**TECHNICAL INFORMATION REPORT**

**Kirkland Townhouses  
10143 NE 64<sup>th</sup> St  
Kirkland, WA**

**City of Kirkland File No.  
Eastside Consultants, Inc. File No. 14069**

Attached are the revised plans per the review comments dated November 20, 2014. The following is an itemized response to your comments:

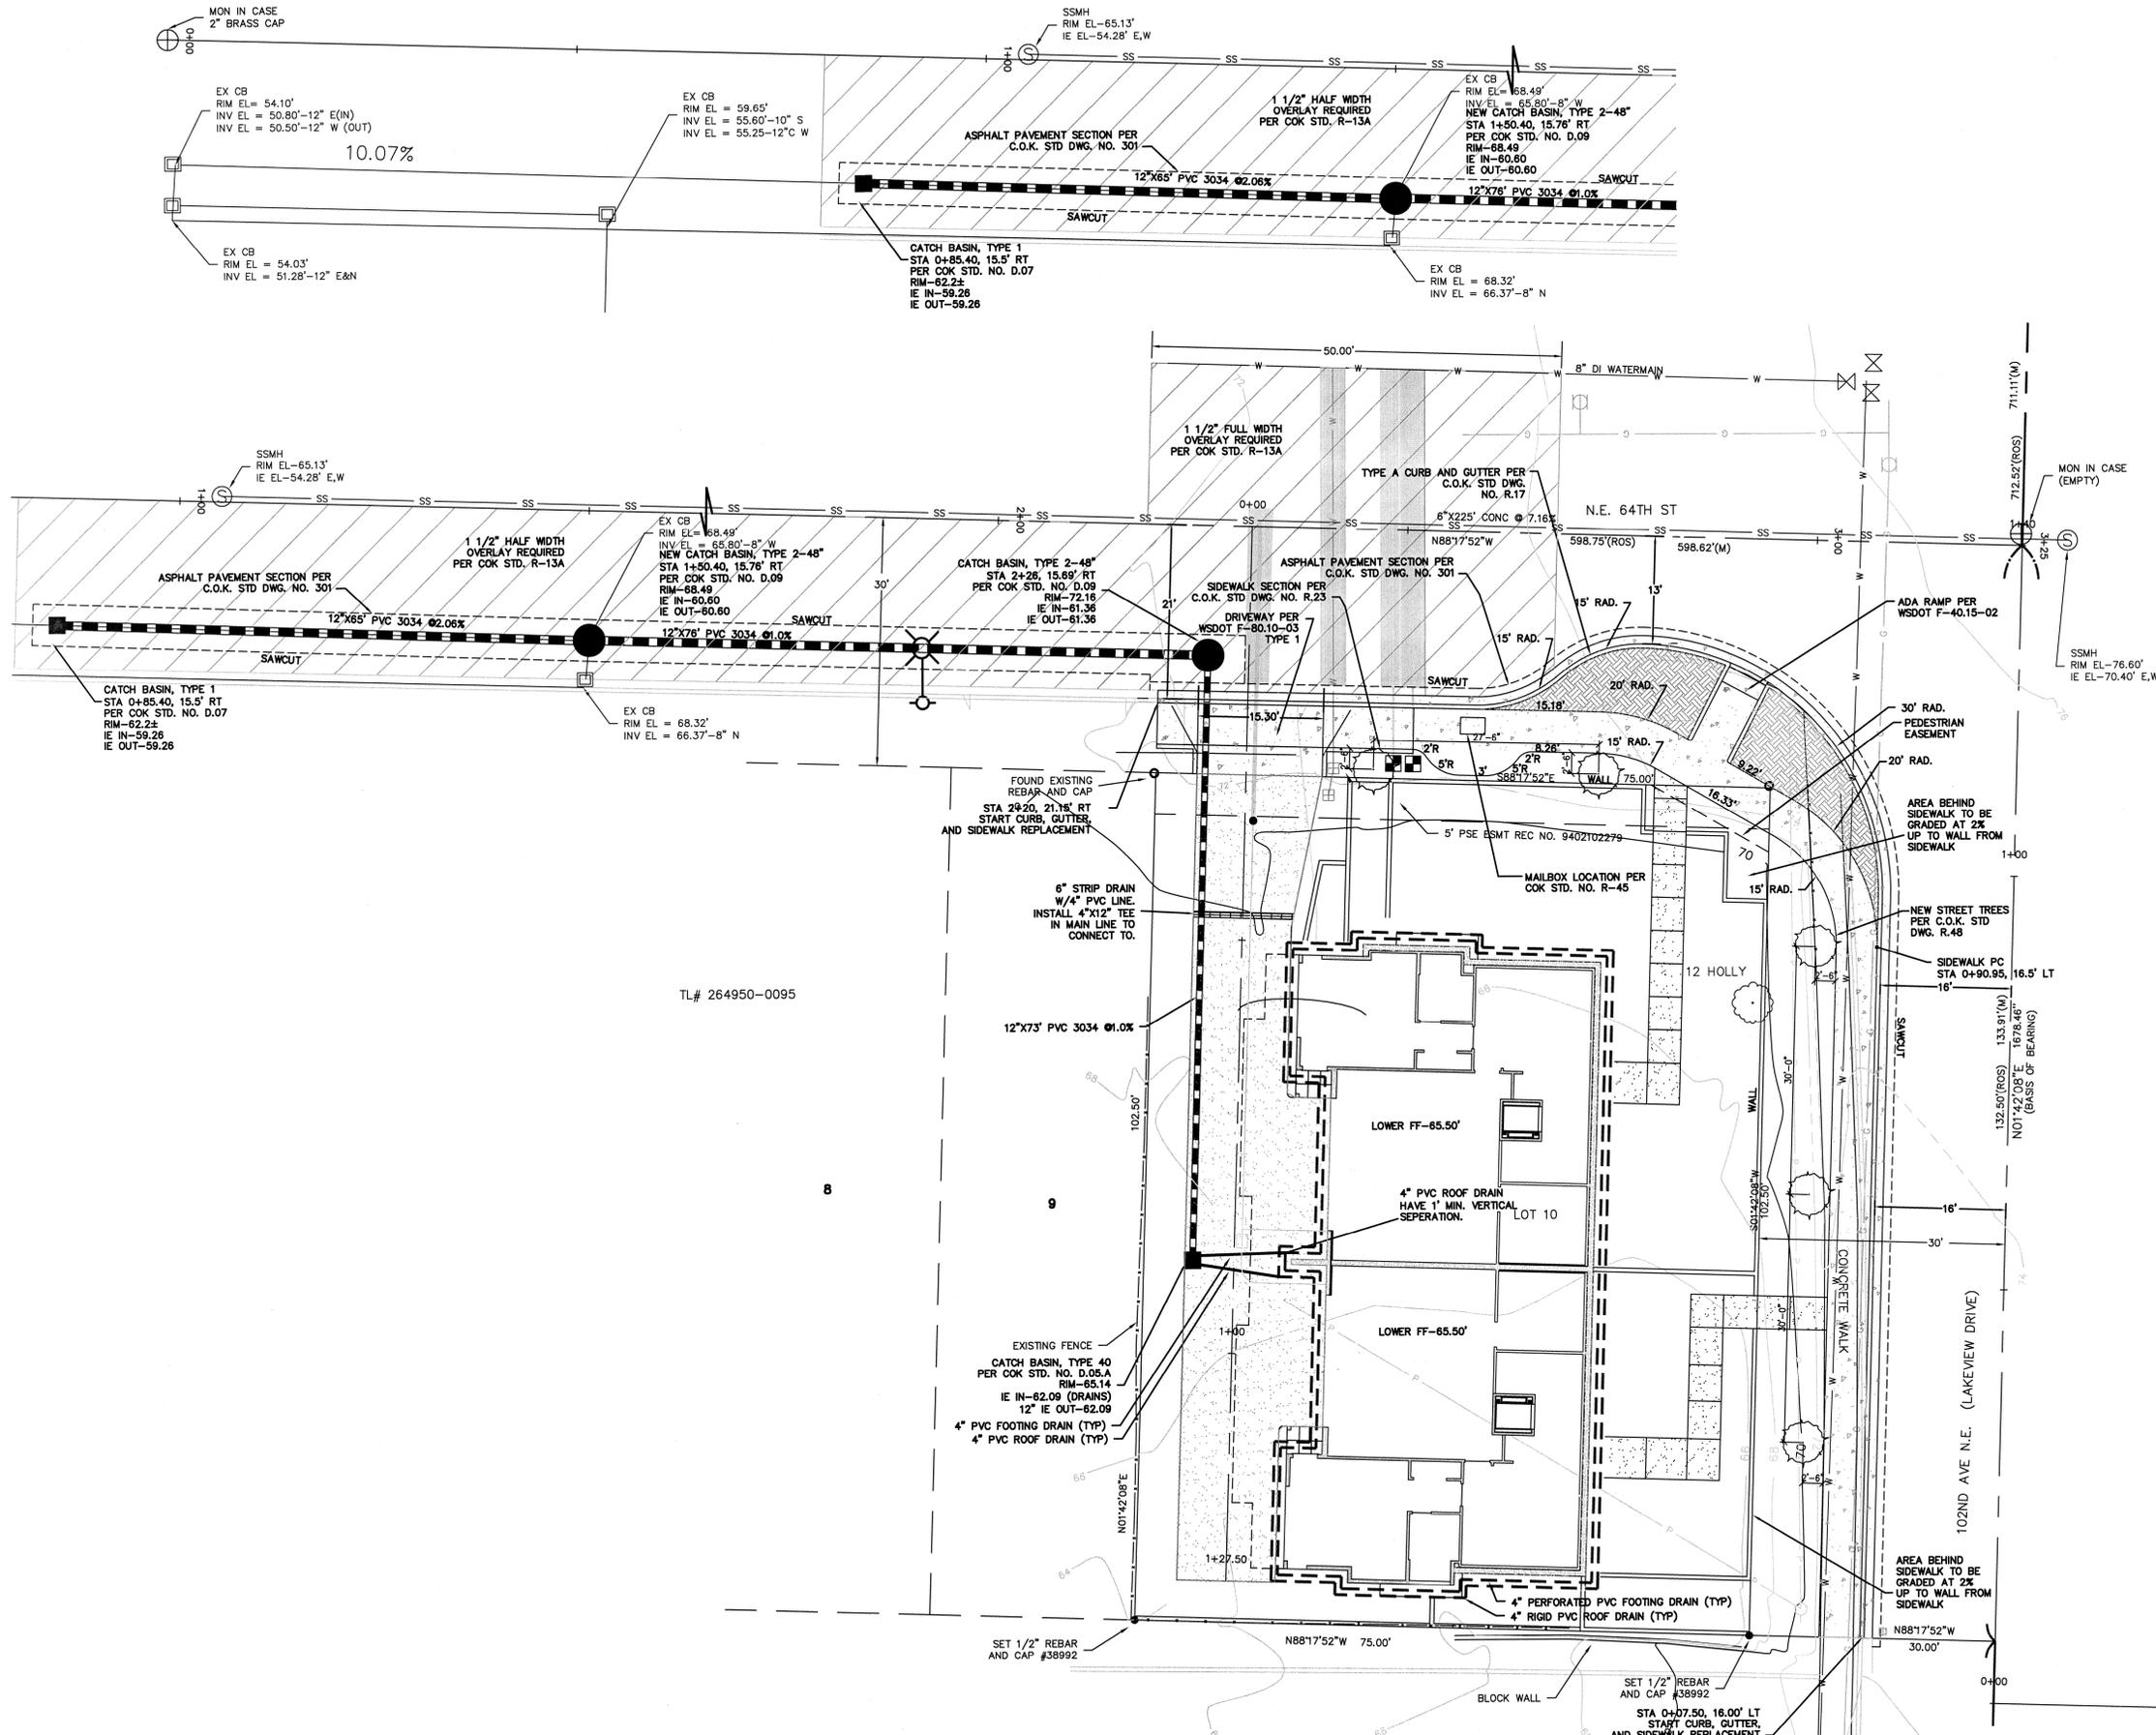
1. Grades and cross slopes were added to sheet 3
2. The pedestrian walkways were shown to connect to the sidewalk at both areas on sheets 1-3
3. The revised driveway detail is called out on sheet 1 and the detail was added on sheet 8.
4. The strip drain connection was added to sheet 1 and 4.
5. The forcemain to gravity connection was changed to detail S.28A. This is shown on sheets 2 and 4, and details of the check valve and box were added to sheet 7.
6. A copy of the original Stormwater Adjustment has been attached to this submittal as well.
